SUNDRY NOTICES AND REPORTS ON WELLS

8. FARM OR LEASE NAME AXI Apache "P"

9. WELL NO. 4

Proposed P&A Sketch (Revised)
AXI Apache P#4

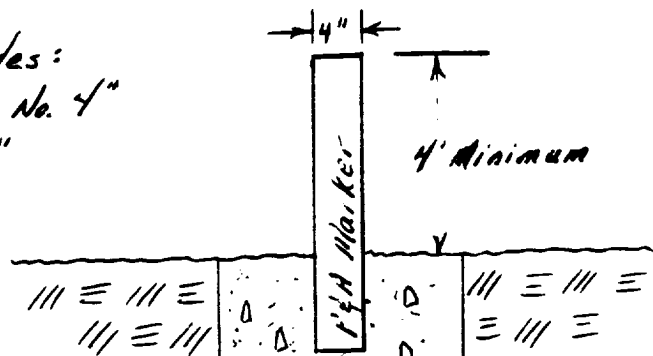
- ① This procedure is different than the approved procedure of 1-7-86.
- ② MURV, Bullhead 55 sxs class "B" cmt w/ 2% CaCl₂ down 2 7/8" csg (This volume will fit in the csg with the top below the point to be perforated for the surface cmt plug)
- ③ Fill hole w/ weighted pkr fluid, then pump 5 add'l bbls of pkr fluid in order to squeeze 25 sxs cmt into perms. Will not exceed 2600 psi surf. press.
- ④ Tag top of cmt @ 1500'; Perf @ 271' w/ 4 JS PF. Establish arc. and pump 100 sxs class "B" w/ 2% CaCl₂ and circ. to surf. Will not exceed surf. press.
- ⑤ Cut csg @ a minimum of 3' below final restored ground level and place abandonment marker in wellbore.
- ⑥ Clean location & rig down. A proposed P & A wellbore sketch is attached.
